Westinghouse Electric Company
Nuclear Power Plants
P.O. Box 355
Pittsburgh, Pennsylvania 15230-0355
USA

Subject: AP1000 Response to Request for Additional Information (SRP 3)

AP1000 TECHNICAL REPORT REVIEW

RAI Response Number: RAI-SRP3.7.1-SEB1-10
Revision: 3

RAI-SRP3.7.1-SEB1-10-1: ASB at Elevation 327.4' X-Direction

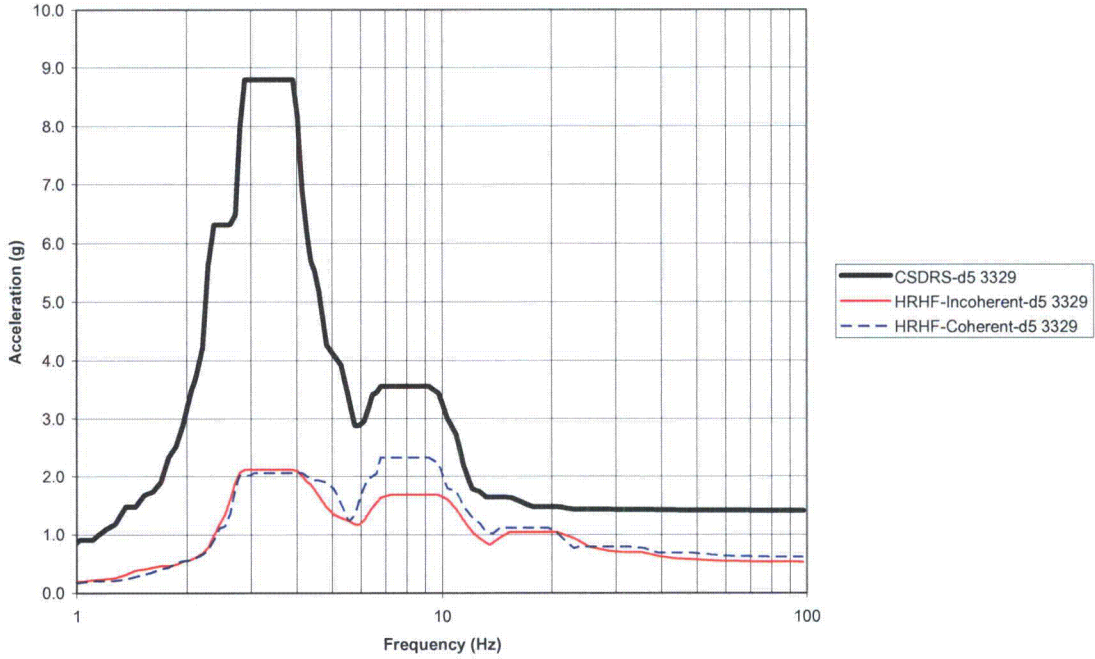
The staff requests that Westinghouse augment Figures 5.2-1 through 5.2-6 in TR-115, by adding the HRHF broadened spectra from the NI20 fixed base analysis, without any reduction for incoherency or other considerations. This will provide the staff with results needed to conduct an evaluation of the effect of incoherency.

- A. Westinghouse will provide explanation why the incoherent response has a significant reduction when compared to coherent response in low frequencies (below 10Hz)
- B. Review interpolation function for NI20 SASSI model.
- C. Reanalysis of seismic response will correct/clarify values and results will be reissued as a new revision to RAI-SRP3.7.1-SEB1-10.

- a. The following is an explanation as to why the incoherent response has a significant reduction when compared to the coherent response at low frequencies (below 10 Hz). The incoherent response below 10 Hz as shown in Figures RAI-SRP3.7.1-SEB1-10-1 to 3, 10-16 to 17, and 10-19 to 21 show significant reduction compared to the coherent response. Node 3329 shows a 26%, 36% and 33% reduction in X, Y and Z direction, respectively. Node 2711 shows a 31% and 30% reduction in X and Y direction, respectively. Node 1757 shows a 12%, 19% and 28% reduction in X, Y and Z direction, respectively. The incoherent runs are based on the 2007 Abrahamson coherency function shown in Figure RAI-SRP3.7.1-SEB1-10-37. The average reduction between 6 to 9 Hz is up to 20% for horizontal and up to 30% for vertical direction.

In response to the question raised by the NRC during May 19-23, 2008, Westinghouse has provided the response spectra for the HRHF broadened NI20 model with coherent and incoherent considerations in Figure RAI-SRP3.7.1-SEB1-10-1 to RAI-SRP3.7.1-SEB1-10-21 (5% damping).

This reduction of incoherent Floor Response Spectra (FRS) in the 6 to 9 Hz range is a cumulative effect of two reductions due to the incoherency effects and the sharp peak clipping from statistical averaging. The sharp peaks are smoothed by averaging the 25 incoherent FRS curves. The reduction due to incoherency is expected based on the 2007 Abrahamson coherency function for hard-rock. It is noted that the 2007 Abrahamson coherency function shows a smaller reduction when compared to the 2005 coherency function which the EPRI report is based on. The HRHF incoherent analysis shows a consistent reduction as shown in the approved EPRI technical report (Reference 1).

RAI-SRP3.7.1-SEB1-10-22: Foundation of Auxiliary Shield Building – Elevation 60.5' X-Direction

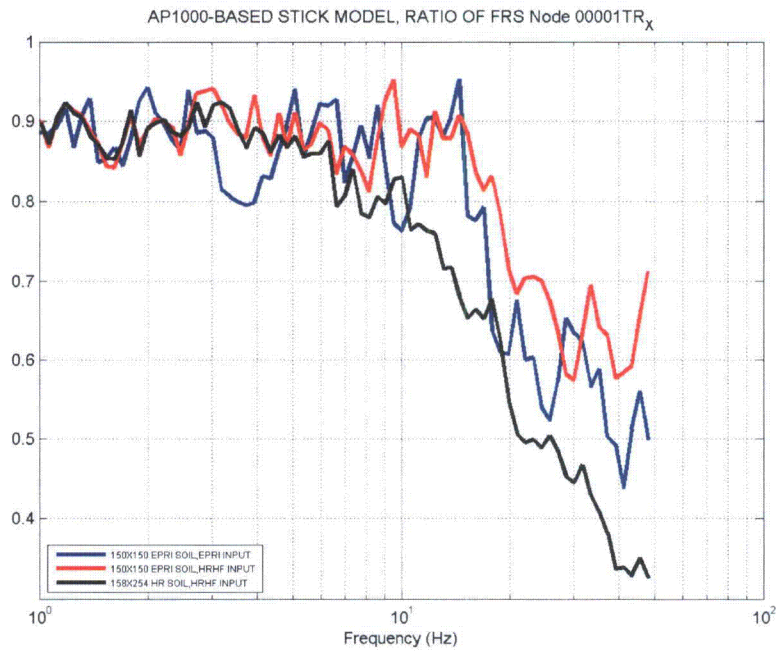
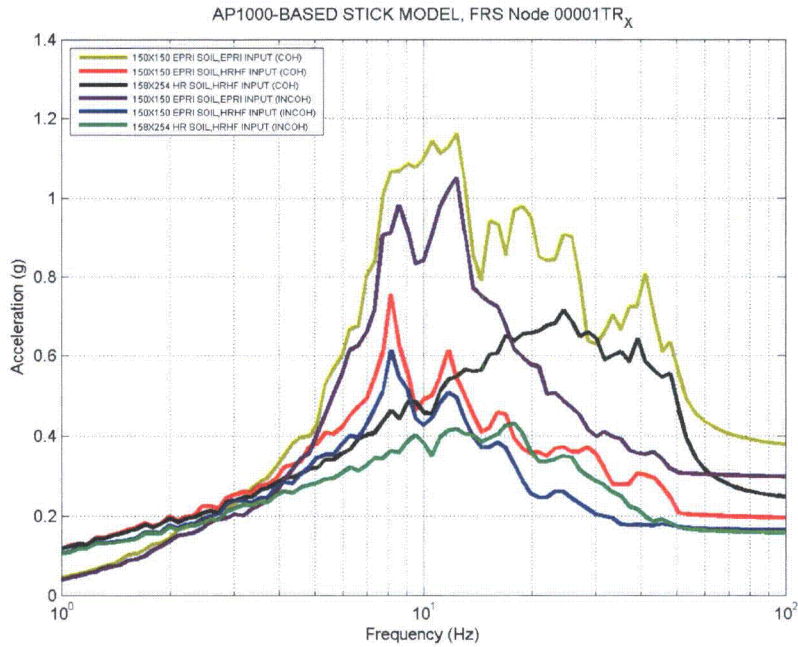
Perform additional calculations using EPRI model and rectangular foundation and AP1000 on hard rock foundation.

The 5% damping floor response spectra of four nodes and the reduction factors (Coh/Incoh) are shown in Figures RAI-SRP3.7.1-SEB1-10-22 to RAI-SRP3.7.1-SEB1-10-33. The Nuclear Island foundation results at elevation 60.5' (Node 1) show that the larger foundation will have larger reduction in response due to incoherency effects. The results for Top of Containment Internal Structure Mass Center at elevation 169' (Node 129), show reductions of the magnitude seen in the NI20 results. The top of the steel containment vessel and the top of the shield building also show similar results.
